TECHNICAL NOTE

25080-TDC-XX-XX-TN-Z-0002-P01

Subject:	Technical Note covering National Highways comments relating 25/00971/REM dated 04.11.2025		
Project Number:	25-080	Author :	JD
Project Address:	Burbage Field Lane, Bullfurlong Lane, Burbage	Checked By:	SD
Date:	16th June 2026	Approved By:	DS

SCHEME
M69 MOTORWAY
(JUNCTION 1 HINCKLEY)
MAJOR MAINTENANCE
DRAINAGE DETAILS SHEET 4

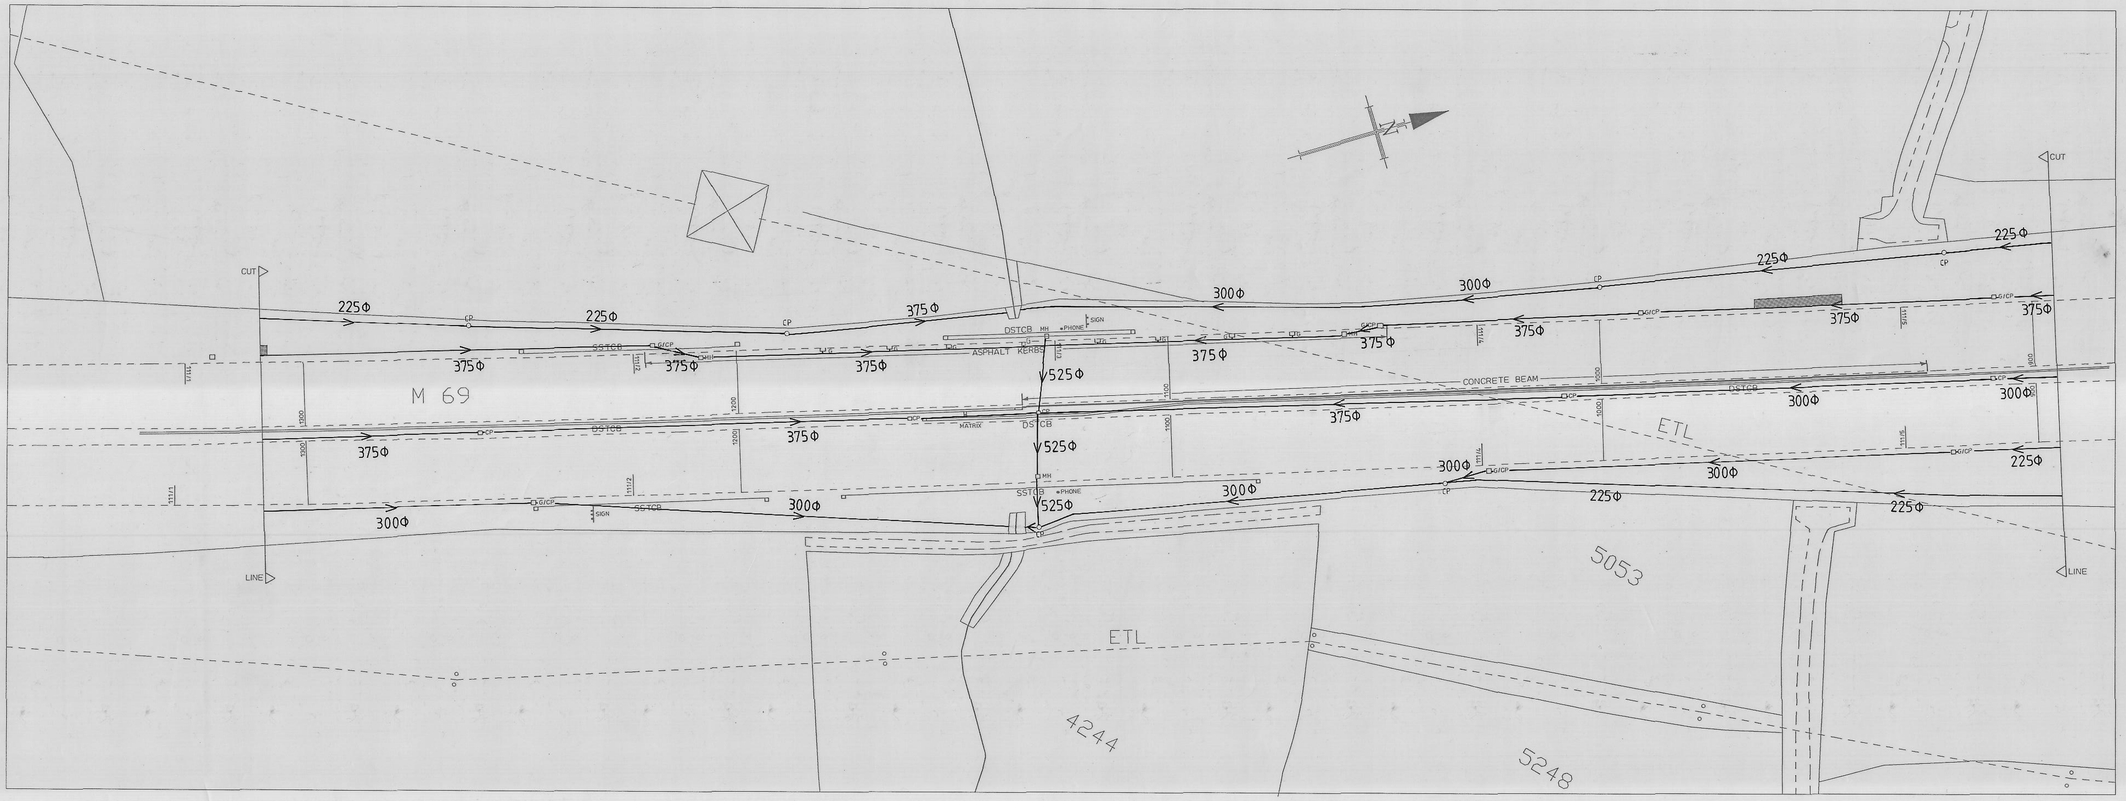
- *Details of how the proposed noise bund will be drained to prevent run-off entering National Highways estate*
- *Details of how National Highways' crest drain along the top of the M69 cutting will be protected from root ingress by the new trees to be planted.*

1.1.5 As part of these responses a review of the NH boundary and drainage records has been undertaken. The NH boundary aligns with the site boundary submitted as part of the application. NH have a crest drain which is seen to drain west from the Lutterworth Road overpass over the M69 along the southern boundary of the site before out falling into the ordinary watercourse. The filter drain is observed to be Ø225 increasing to Ø300 approximately halfway along the site boundary. The filter drain is located wholly within NH land.

2.1.6 The bund is proposed to be landscaped with native planting at 1m (shrub species) and 2m (tree species) centres including tubular guards and stakes. In order to ensure protection of the NH crest drain it is proposed to install a vertical root barrier to a depth of 1m below the existing ground level to prevent future roof ingress into the NH land.

Title: Noise Bund Layout

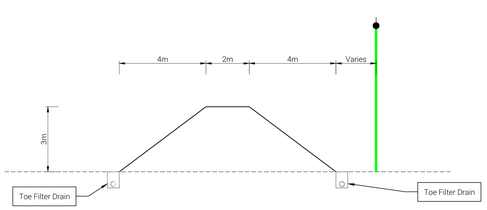
The recent drawing(s) show a more definitive plan of the proposed noise bund, but still no details of the height of the bund or the geometry of the bund slopes are available. Due to the proximity to the SRN boundary, further details are required to understand the potential impact of this bund on the SRN and subject to DMRB CD622 compliance with regard to the extent of any geotechnical risk.

The bund appears to be located along the at grade section of the boundary. Representative, dimensioned cross sections through the bund, extending to the NH boundary at least, are required.

2.1.1 The proposed bund is to be located wholly within the applicants land ownership and is to be 3m in height with a 2m noise fence located on top. The banks are to be formed with 1in1.33 slopes. The bund is proposed to be formed using clean, site won material, subject to geotechnical testing to confirm suitability.

2.1.2 Drawings indicating the noise bund general arrangement along with cross sections can be found within Appendix C.

2.1.3 The noise bund is proposed to be drained via filter drains installed to the toe of each slope to capture runoff at the source and direct it towards the existing unnamed watercourse to the eastern boundary of the site. This arrangement would mirror the existing land drainage arrangement on the site.

2.1.5 The toe of the bund is located circa 1.5-2.5m (distance varies) away from the site boundary to allow sufficient room to construct the filter drain whilst also maintaining sufficient construction room to ensure protection of the NH boundary and assets.

Toe filter drains to outfall into existing watercourse subject to LLFA Ordinary Watercourse Consent

Toe filter drain to prevent runoff onto National Highways Land
